CIVIL CONSTRUCTION DOCUMENTS
FOR
ATANDO AVENUE APARTMENTS
1440 NEWLAND ROAD
CHARLOTTE, NC

*Revision
RELIMINARY PLANNED
MULTI-FAMILY SUBDIVISION
APPROVAL
CHARLOTTE-MECKLENBURG PLANNING DEPARTMENT
By Brent Wilkinson 7/28/16

August 14, 2014 Addendum 03
12044

SITE PLAN

C1.1

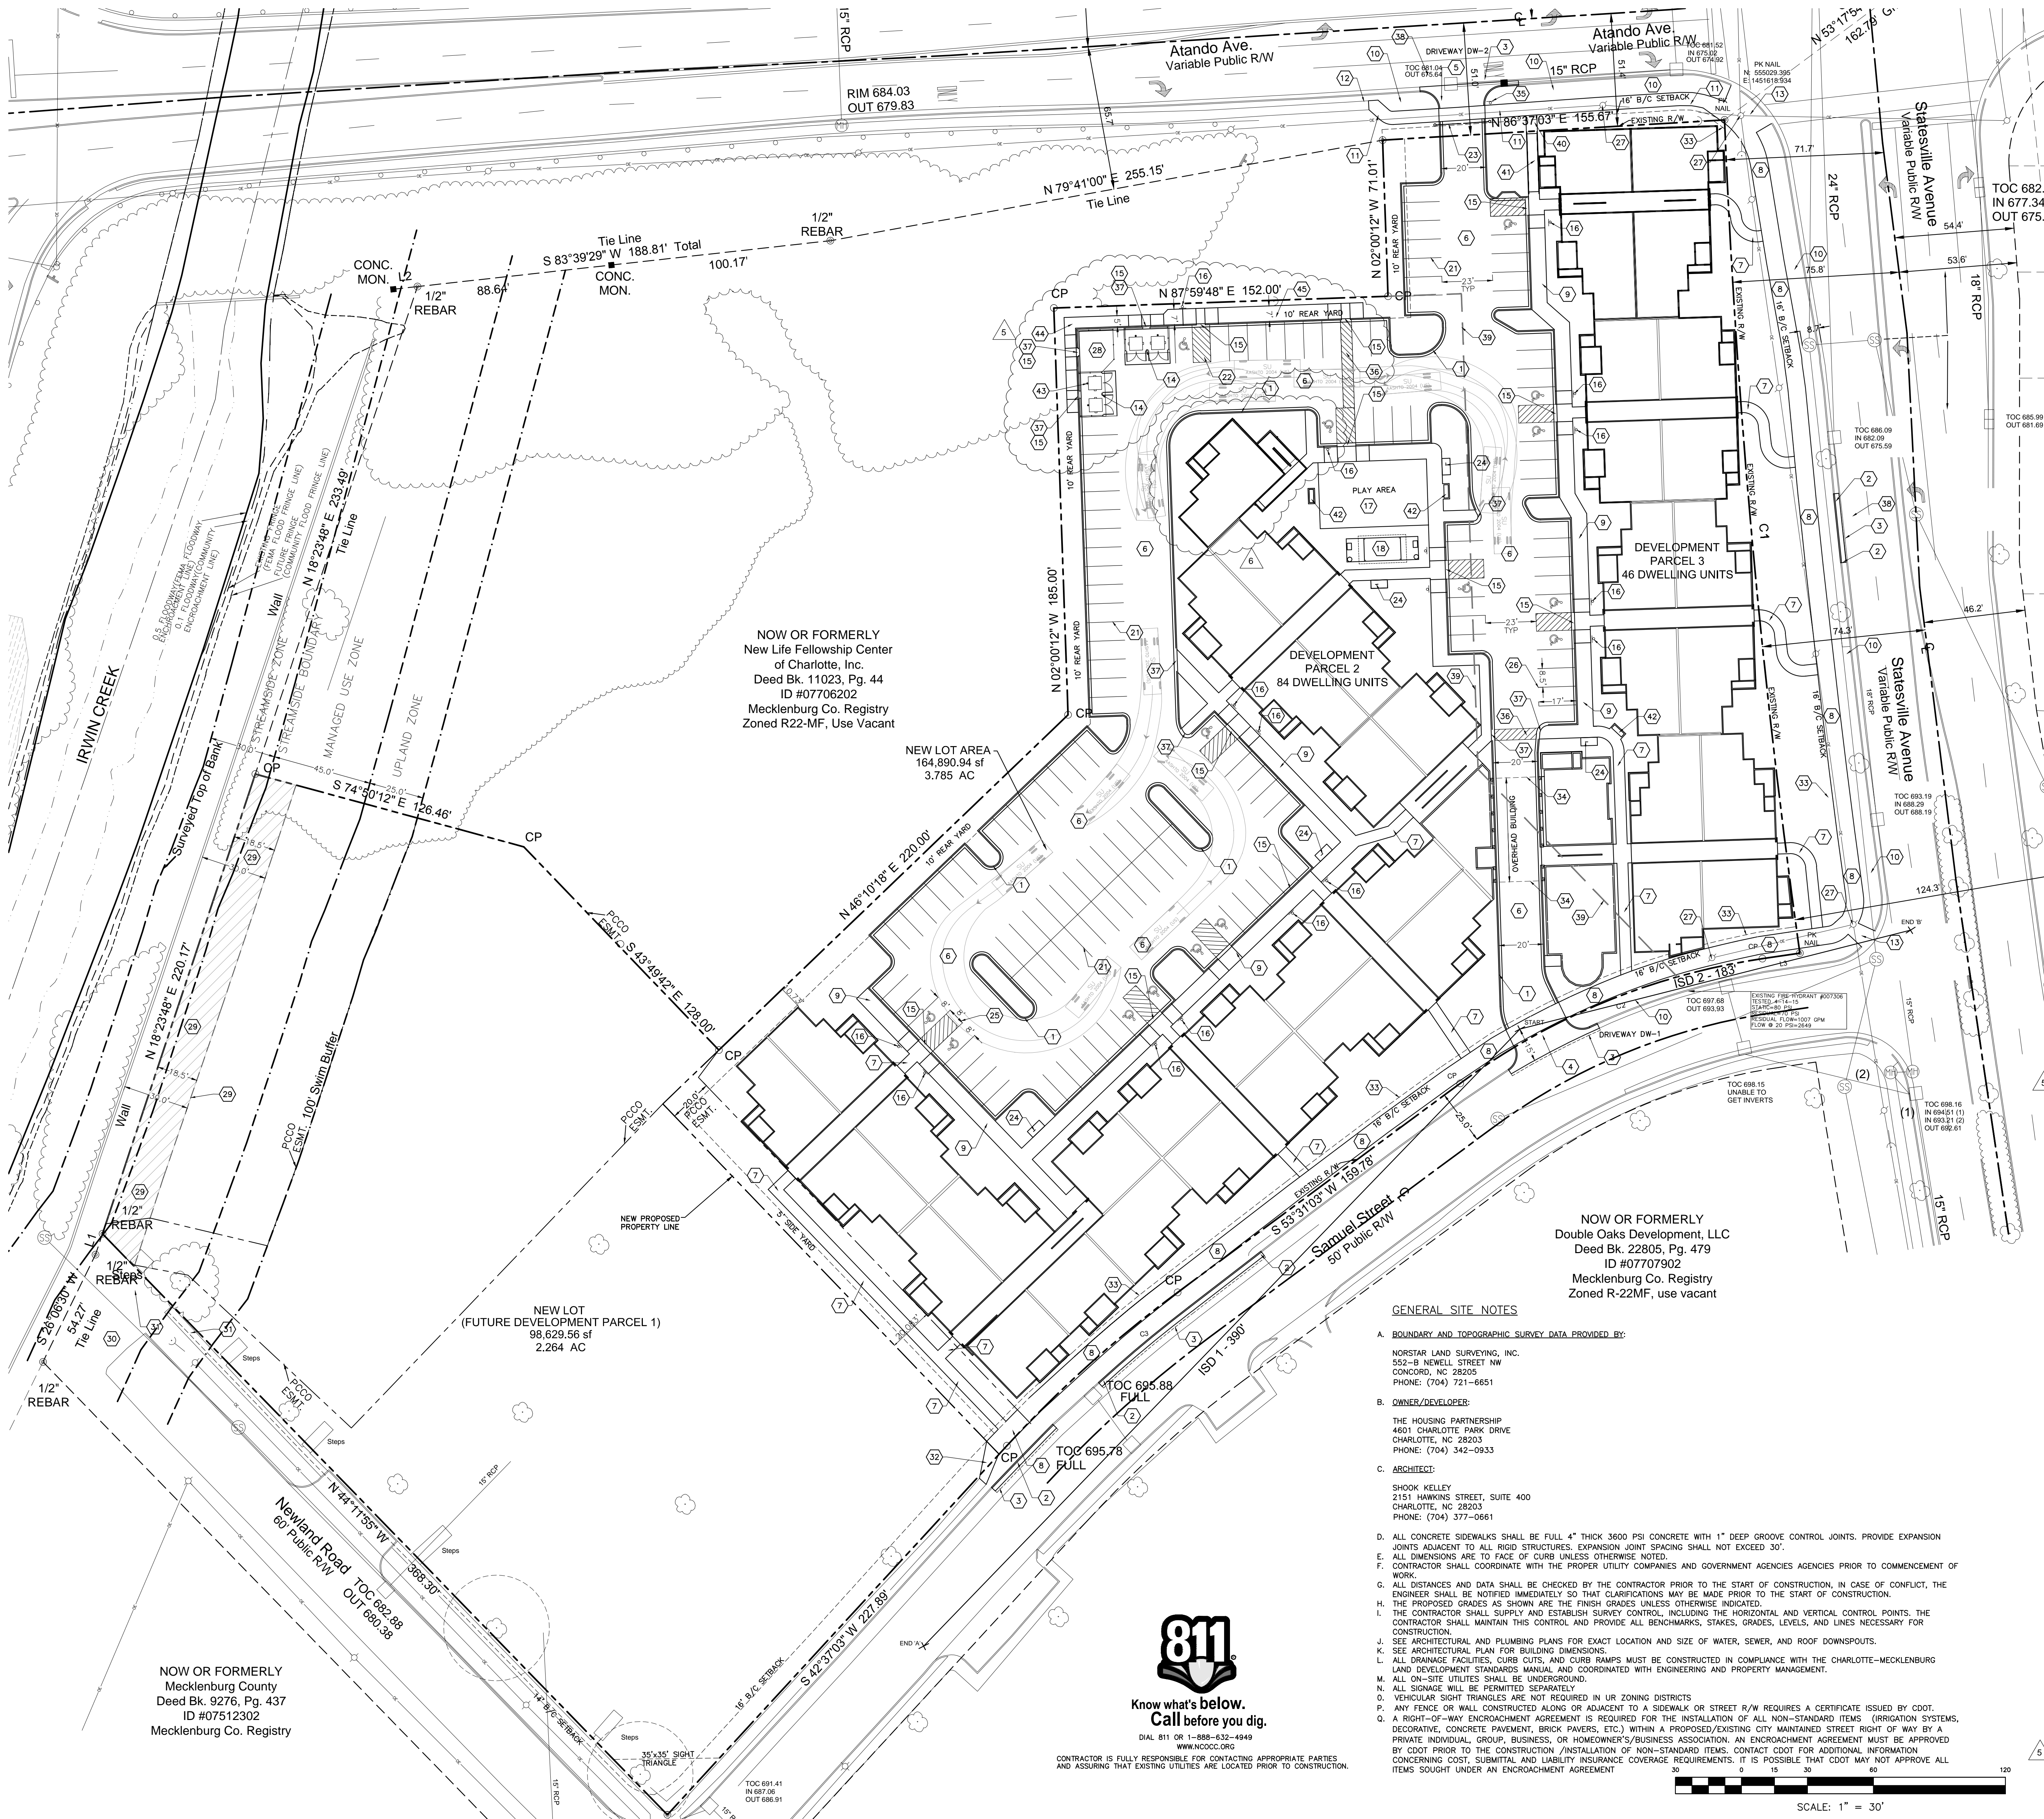
*Solid waste collection has been revised from two (2) 8 cubic yards compactors with compactor in a single enclosure to four (4) 8 cubic yard containers within 2 enclosures. Revised truck turning diagram accordingly.
Solid waste and recycling enclosures have been revised to be accessible and on an accessible route with sidewalk and crosswalks per review comments from NCHFA. A single 40'R required tree has been relocated due to the revisions above, but the tree ordinance remains compliant with regard to tree to parking distance.
